CROSSROADS NORTH

EARLY GRADING & EROSION CONTROL PLANS

EL PASO COUNTY FILE NO. SP 20-207

EARLY GRADING & EROSION CONTROL PLAN

GRADING & EROSION CONTROL PLAN

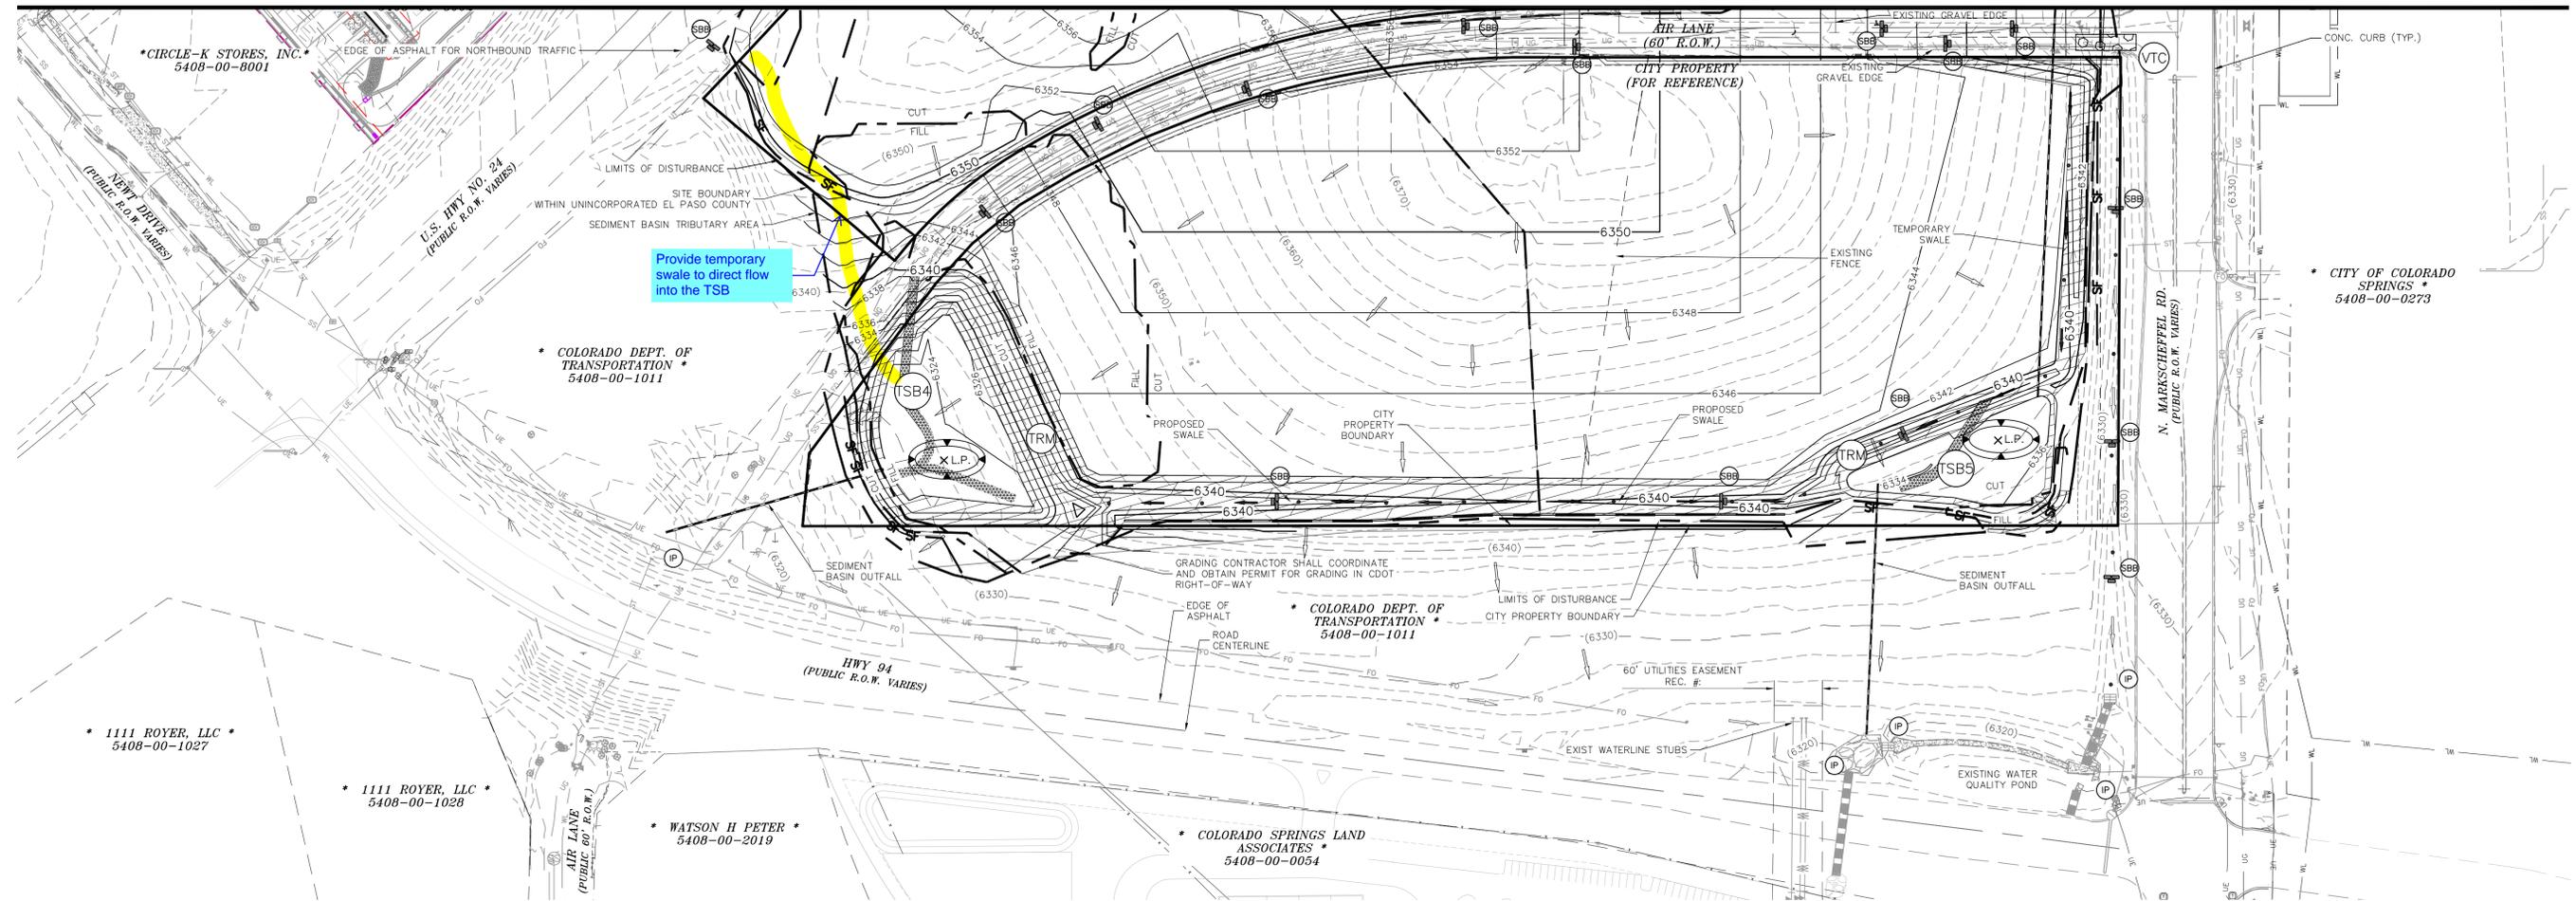
Provide additional information regarding the proposed berm, preferably as a typical cross section. Identify the side slope, max height, crest width.

Show how/where TSB2 discharge. Why not grade in a temporary swale from the L.P. to TSB3?

Add the hatching on the legend. Identify the material used.

Provide typical cross section. The east side appears to be an embankment. The should be a minimum width of 12 ft at the top of the embankment structure per DCM 11.3.3.

Revise pipe layout to provide a smooth low head loss transfer of flow.

See comment on the TIS. Markscheffel Rd is anticipated to be 6 lanes as such ROW dedication appears to be required.

Provide typical cross section detail of the retaining wall. Cross section to encompass the proposed swale, retaining wall, roadside ditch.
 - Identify the swale lining used.
 - Add a note that building permit is required since the retaining wall is greater than 4'
 - Label the specific retaining wall product/system proposed. Make sure the retaining wall offset from the ROW is sufficient so the retaining wall does not extend into the ROW.
 - Identify the max height of the retaining wall.
